County of Loudoun
Department of Planning
MEMORANDUM

DATE: April 2, 2010
TO: Loudoun County Planning Commission
FROM: Judi Birkitt, Project Manager
SUBJECT: April 7, 2010 Planning Commission Work Session
Kincora Village Center, ZMAP 2008-0021

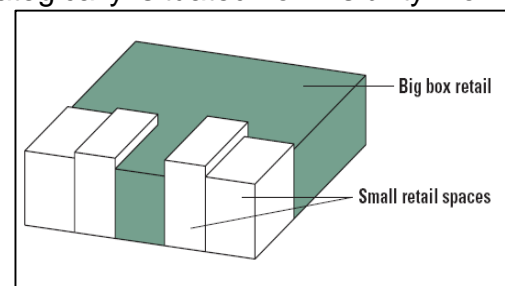
Broad Run Toll House and Bridge Ruins - At the March 10, 2010 Planning Commission work session, the Commission requested that staff work with the applicant

to articulate a Pacific Boulevard envelope that would include the two more southern alignments and eliminate the northernmost alignment so that the Broad Run Toll House and bridge ruins could be preserved in place. The applicant noted at the meeting that avoiding the 0.83-acre historic property entirely may not be possible due to engineering and topographical considerations.

At a March 18, 2010 meeting with County staff, the applicant provided an updated illustrative that shows a reduced envelope that excludes the alignment that would most impact the toll house; the envelope does include the northeastern tip of the Toll House property. Staff notes that the road alignment could encroach onto the property approximately 50 feet and could come within approximately 100 feet of the Toll House.

Staff recommends that the applicant include proffer language stating that, if right of way is needed within the parcel boundary of the property, the right of way, including the limits of clearing and grading for road construction, will not occur within a maximum of 150 feet of the Toll House or the bridge remains. Staff notes that any encroachment into the property will have an impact on the County's historic site district designation for this property and coordination with the County's Historic District Review Committee will be required.

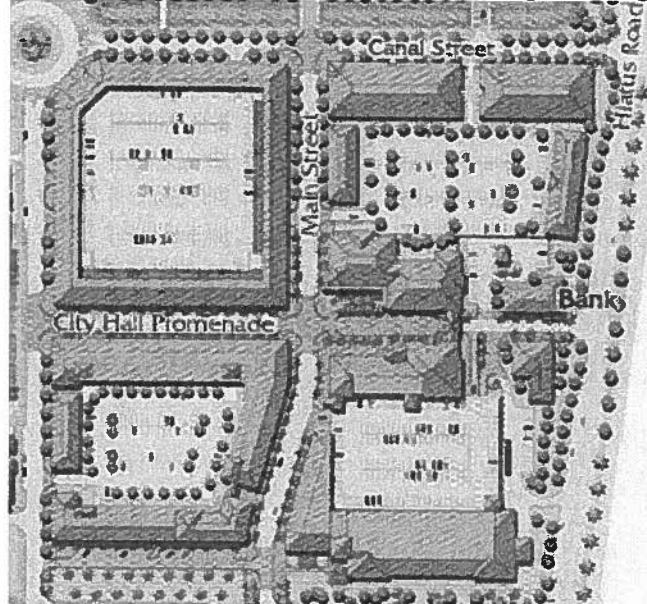
The applicant has revised Proffer II, Building Heights to provide the minimum height or stories of buildings adjacent to Route 28 and Pacific Boulevard. Staff notes that Proffer II provides that buildings with frontage along the west side of, and within 100 feet of Pacific Boulevard within Land Bays B, F, and J with no intervening buildings between such buildings and Route 28, shall be constructed to a minimum of 4 stories or 50 feet. However, staff notes that Proffer VL1 permits buildings in Land Bays B, F, J, and N fronting on Route 28 or Pacific Boulevard to be setback a maximum of 150 feet.

To ensure the Route 28 Corridor develops as an employment corridor as envisioned by the Plan, staff recommends removing “and within 100 feet” from Proffer II to ensure that all buildings fronting Pacific Boulevard will be a minimum of 4 stories or 50 feet in height.

Attachment A: Heron New Nesting Area Photographs

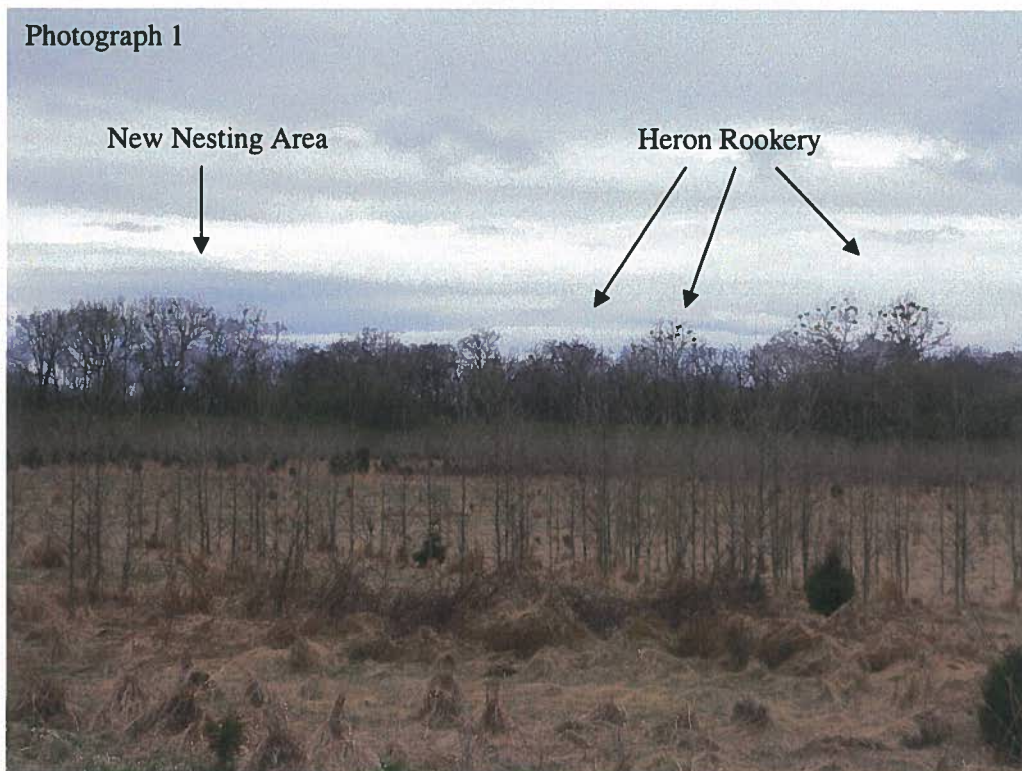
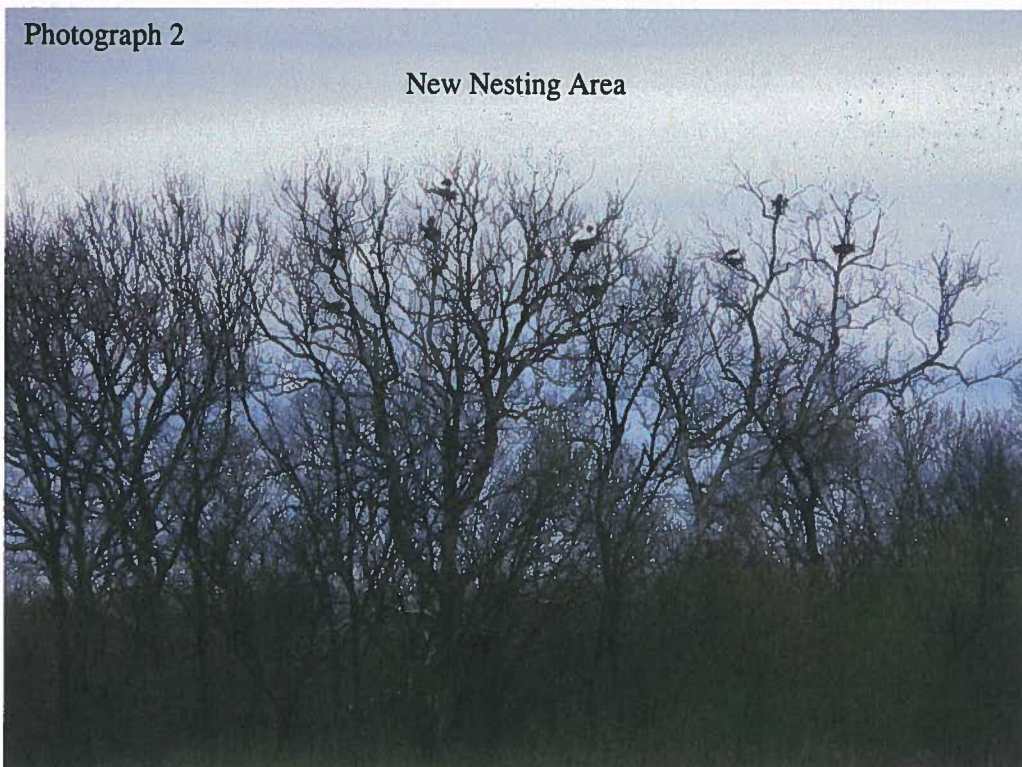
Protection of Herons - During a recent site visit for an application on an adjacent property and a follow-up site visit on the Kincora, eleven additional heron nests were identified approximately 600 feet upstream of the heron rookery on the bank of Broad Run on the Kincora property. The Virginia Department of Game and Inland Fisheries (DGIF) has indicated that the agency will extend the boundaries of the colony to include the new nesting area. In light of this new information, staff recommends that the 700-foot and 1,400-foot buffers be revised on the Concept Plan to account for the new nesting area. The revised 700-foot buffer does not appear to affect the Kincora development, considering the area is designated as a Riparian Reforestation Area. However, the 1,400-foot buffer extends farther into Land Bay C and would preclude a larger area from construction activities during the nesting season.

Pacific_Blvd_Steep_ Slopes.PDF

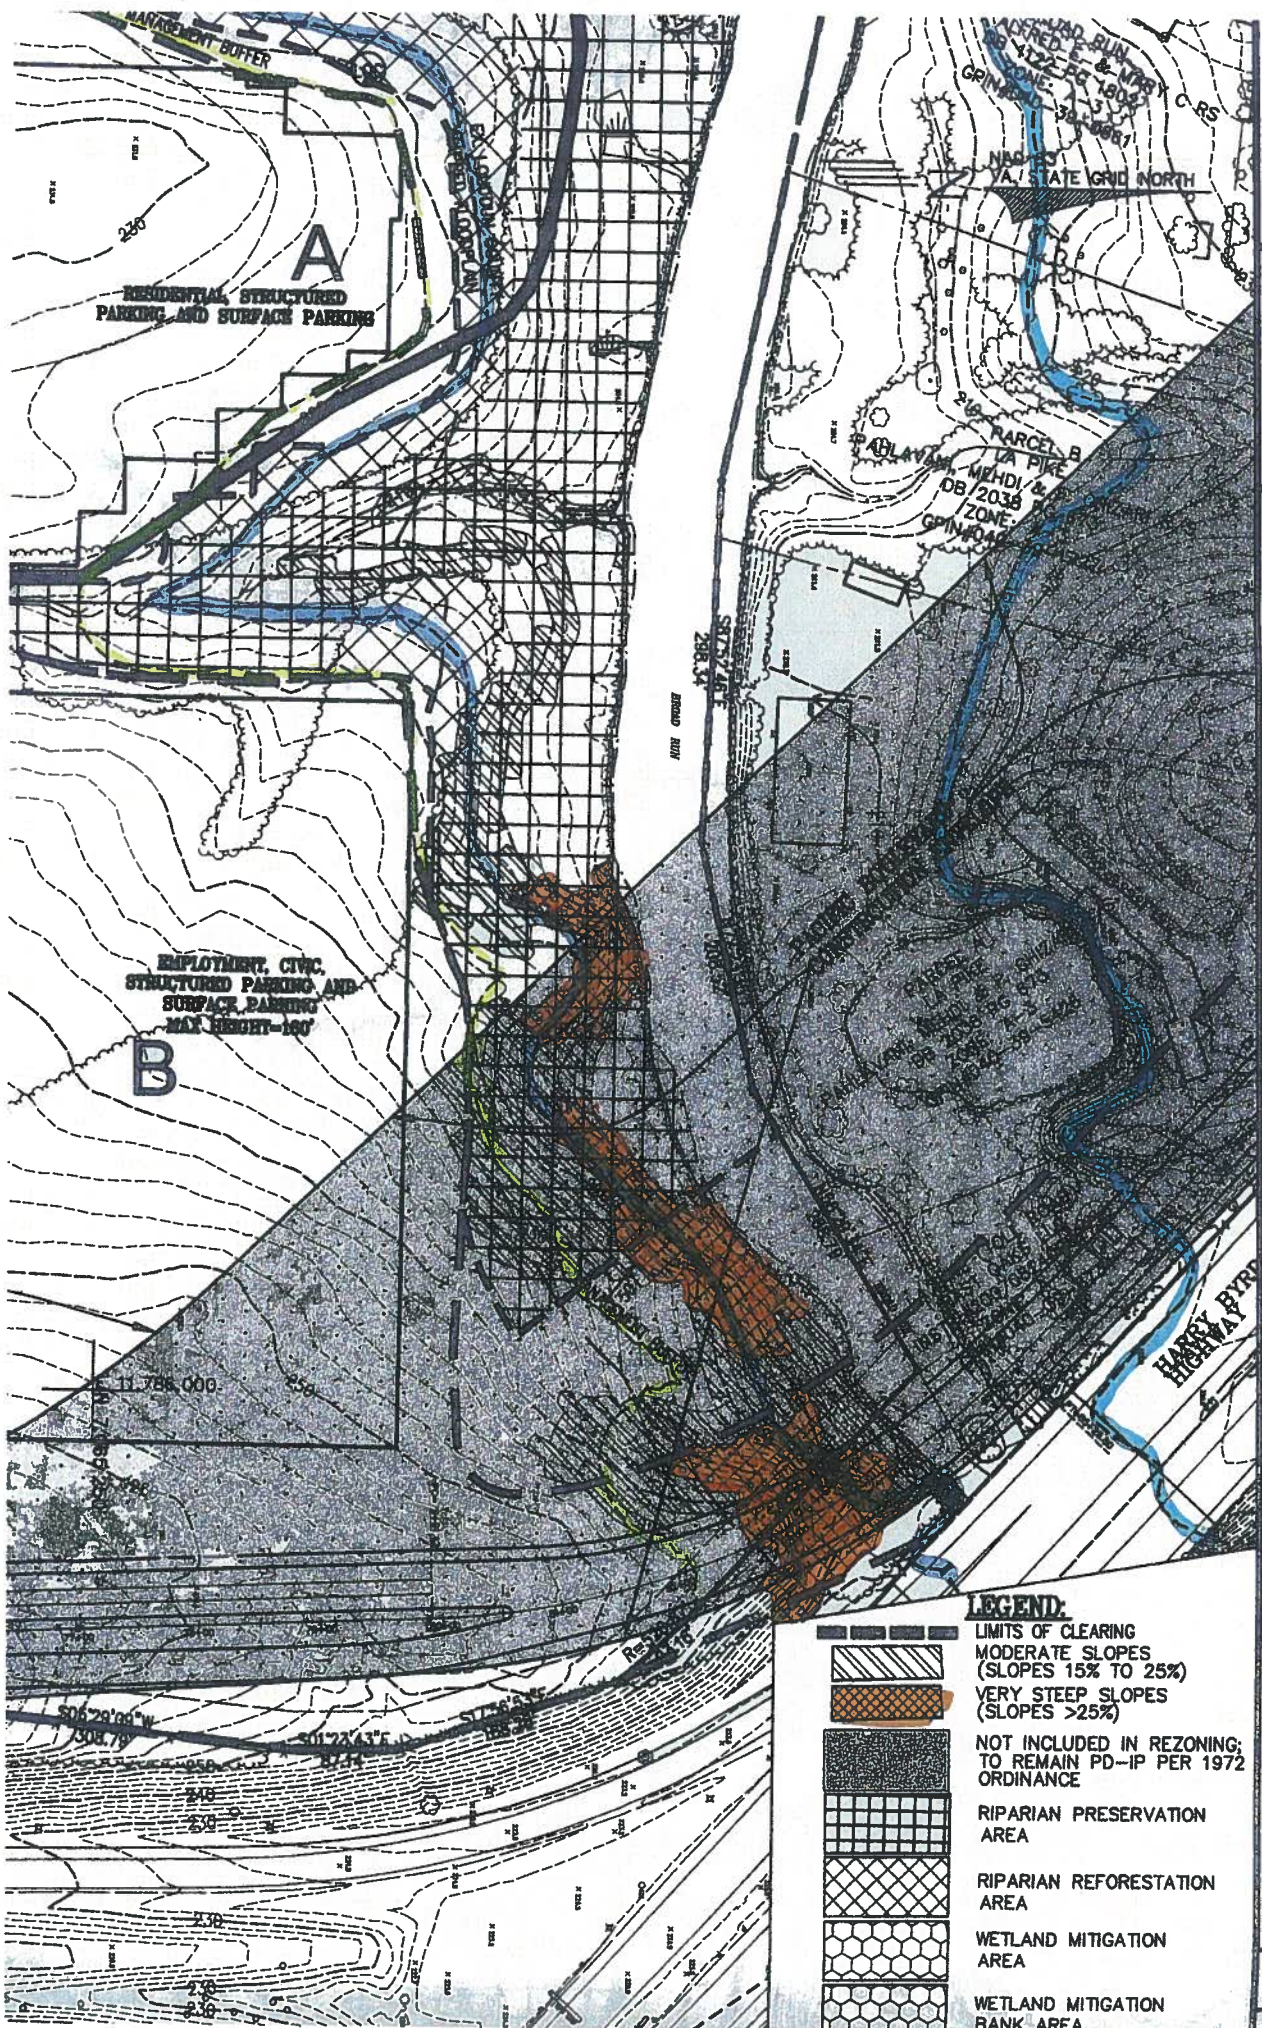
Also, note that all three alignments impact very steep slopes, which is not permitted per Section 5-1508(D) of the Revised 1993 LCZO (see attached pdf, portion of Sheet 11). Recent discussions with Zoning as well as the County Attorney's Office, has indicated that in order to proceed a zoning modification may be pursued to modify the Steep Slope Development Standards for roads, or the Pacific Boulevard Construction Envelope may be excluded from the land area being rezoned, allowing it to remain under the 1972 ZO and not subject to the Steep Slope Standards.
